20 January 2021

Dear Dr. Andrew Sayer:

In response to the positive and constructive comments from the reviewers, we send you the authors' response to the questions and concerns raised by the reviewers.

Reviewer 1: Dr. Frans Snik

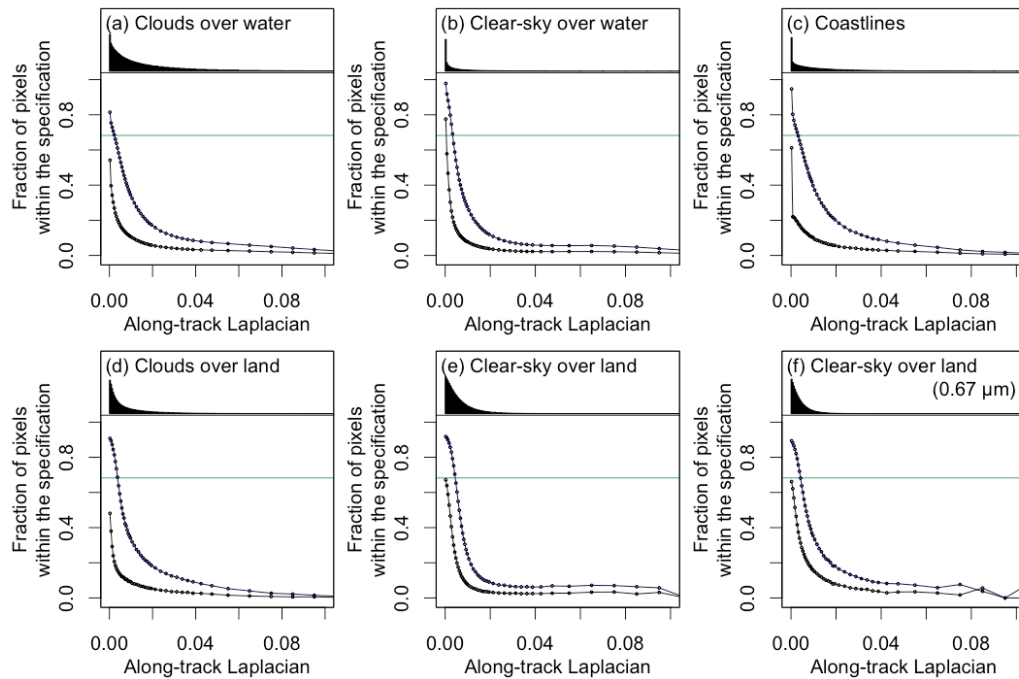
- It would be highly useful to list the polarimetric requirements for 3MI to put these results into context.

- Please relate the errors to the total error budget of the 3MI.

We appreciate this suggestion very much, along with similar suggestion by other two reviewers. It is indeed important to put the results into the context of the system requirements. To put our results into wider perspectives, we're providing here a comparison to both the previous POLDER requirements and the targeted 3MI ones. The target polarimetric accuracy of the 3MI sensor is  $5 \times 10^{-4}$  in terms of polarized reflectance over homogeneous clear-sky over ocean (Fougnie et al. 2018). Figure A1 shows the fraction of pixels that satisfy this condition as a function of the along-track Laplacian (black points and lines). The blue points and lines indicate the fraction of pixels that satisfy the POLDER specification, which is  $1 \times 10^{-3}$  in terms of polarized normalized radiance. Given that 68.2% of data falls within the  $\pm 1\sigma$  when the error distribution follows the normal distribution, we could interpret that the specification is well satisfied in a particular bin when the fraction exceeds 68.2%. Over very homogeneous scenes with low along-track Laplacian, indeed we find that the requirements are satisfied, but obviously not anymore as the along-track Laplacian (i.e. inhomogeneity of the scene) increases. This result is consistent with the study by Fougnie et al. (2007), which shows that the POLDER data over homogeneous scene satisfies the requirement. In the revised manuscript, we add one paragraph that discuss this point.

The 3MI's target error in the polarimetry is defined on clear-sky homogeneous scene over dark surface (Fougnie et al. 2018 JQSRT), and the value is  $5 \times 10^{-4}$  in terms of polarized reflectance. In Fig. A1, we show the fraction of pixels that satisfy the target accuracy for each bin of along-track Laplacian. Given that 68.2% of data falls within the  $\pm 1\sigma$  (i.e. RMSE) if the error distribution follows the normal distribution, we could interpret that the specification is well satisfied in a particular bin when the fraction exceeds 68.2%. The figure shows that the 3MI target accuracy will be met for fairly homogeneous scenes (low along-track Laplacian), but with an increase of inhomogeneity, the target accuracy would be difficult to be met.

Figure A2. The schematic diagram of the field-of-view by the (a) 3MI and (b) SGLI. The black arrow shows the motion of satellite along the orbit, and the three position of the satellites along the track are shown to highlight asynchronous acquisition by the 3MI sensor.

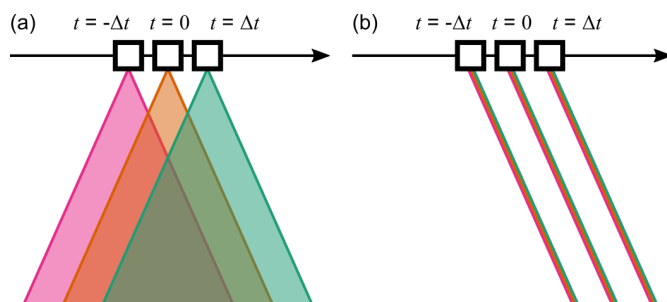
- Please discuss in detail the commonalities and differences as hinted at in Section 2.1 between the polarimetric implementations of SGLI and 3MI. A cartoon figure may come in handy.

We appreciate the suggestion from the reviewer. We add a paragraph clarifying the commonalities and differences between the SGLI and 3MI in the revised manuscript. A cartoon figure as shown in Fig. A2 is added to highlight that the commonality is the measurement principle (three intensity measurements with linear polarizer at different angles) and the difference is the acquisition arrangements.

Figure A3. Simulated clouds with the different power-law spectrum slope. (a) No correlation, (b)  $-5/3$ , and (c)  $-3.0$ .

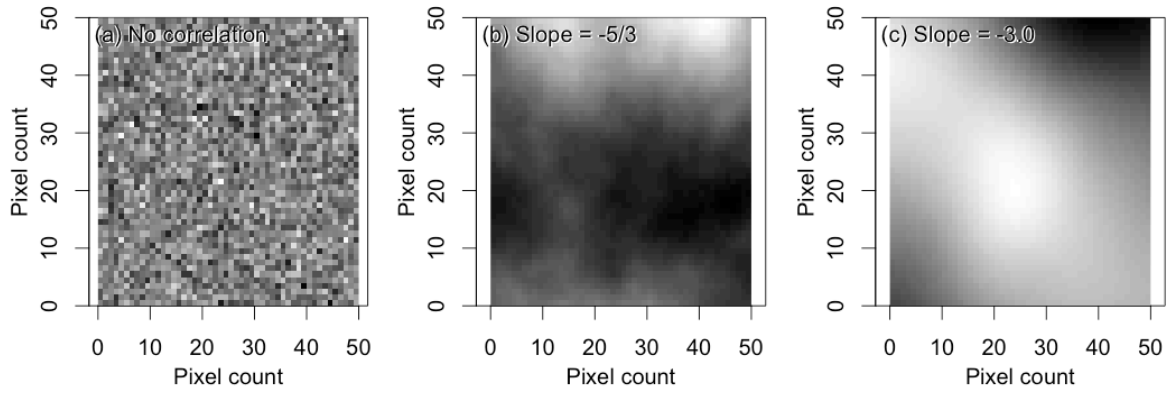
- It would be insightful to also present intensity and polarimetric images for typical simulated cloud scenes for particular power law distributions.

Thank you very much for the suggestion. As the simulation is performed for every 3MI pixel, the image size is  $20 \times 4$ , and not suitable for the visualization. It is possible to perform a simulation for a large scene only for the illustrative purposes, as shown in Figure A3. However, we are afraid that the inconsistent figure to the simulation method introduces more confusion than the understanding. The paper by Szczap et al. (2014, Geosci. Model Dev. 7. 1779-1801) is also helpful to visualize the impact of the methodology used in the simulation of cloud fields.

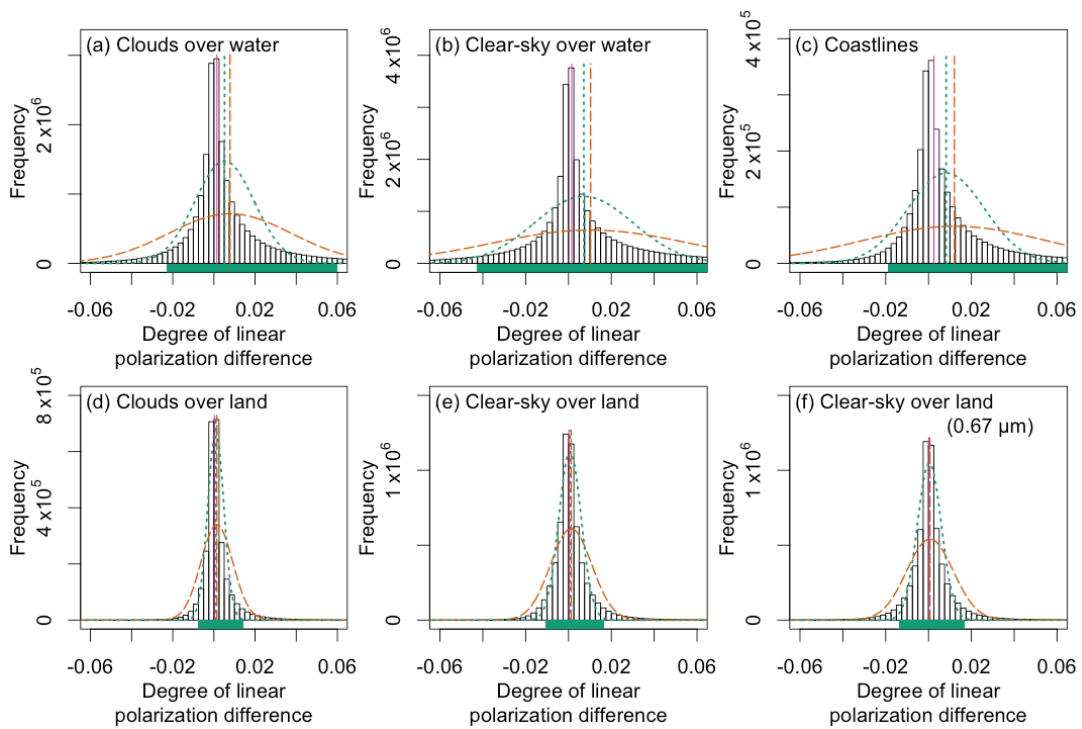
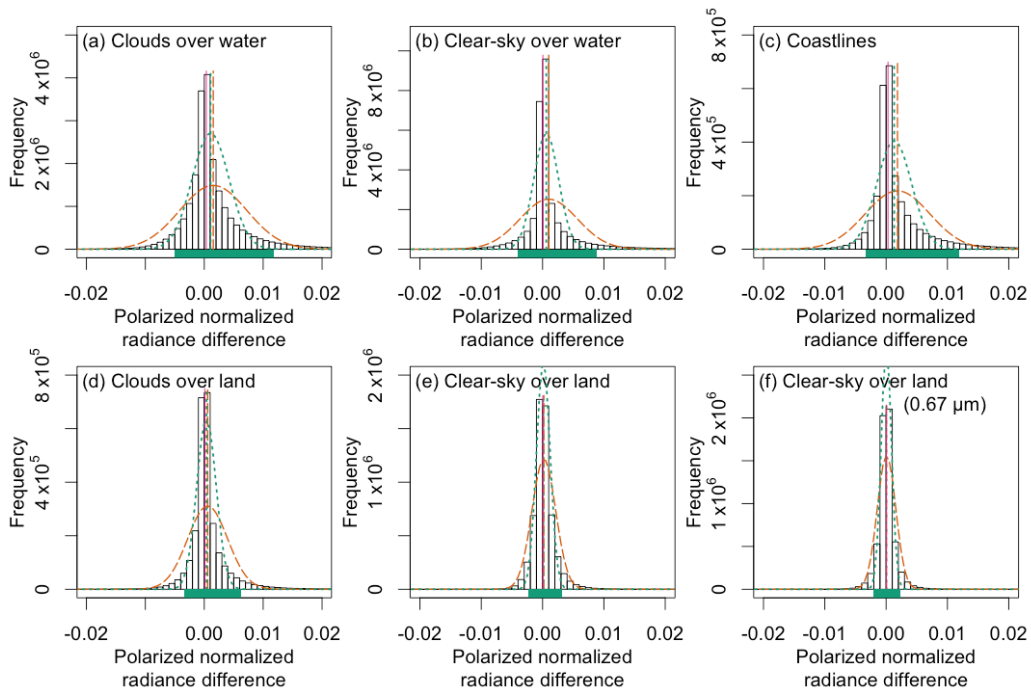
- Also the case of clear-sky over ocean would be interesting.

We add this class in the revised manuscript as in the histograms in Figs. A4 and A5. Indeed, the  $L_p$  errors are small compared to the cloudy scenes. The DOLP errors are larger because of highly polarized dark ocean.

Figure A6. (a) The DOLP difference between proxy and reference data. (b) The visible composite of the SGLI Level 1B data the same zone (visualized by authors, original data by JAXA).

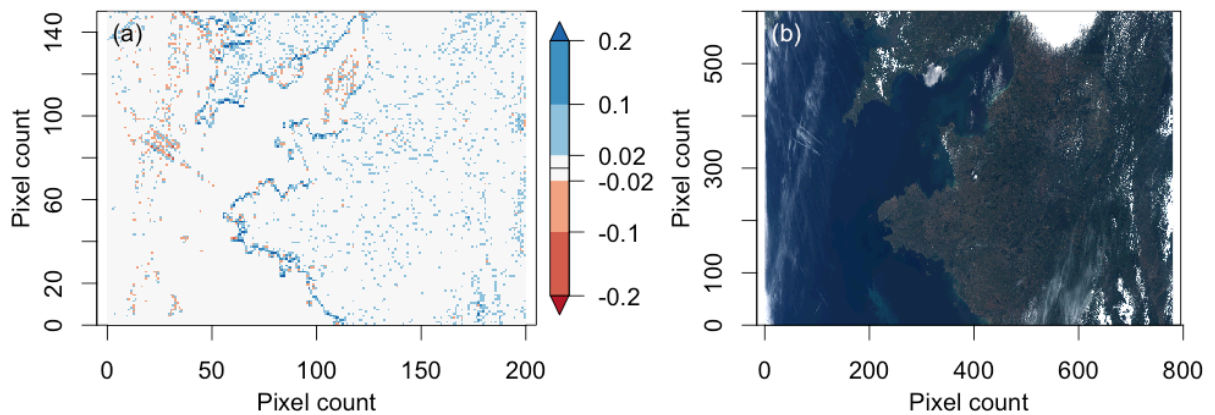
5. The coastlines appears to be significantly biased but not clouds, particularly over land. Color scale issue?

Figure A6 is the same figure with a modified color scale. The error over the land cloud is not still evident, and our understanding is that the land at 0.869  $\mu\text{m}$  over this region is bright enough that the reflectivity contrast to the cloud is not as significant as that over the ocean. In the revised manuscript, we include the figure with the new color scale.
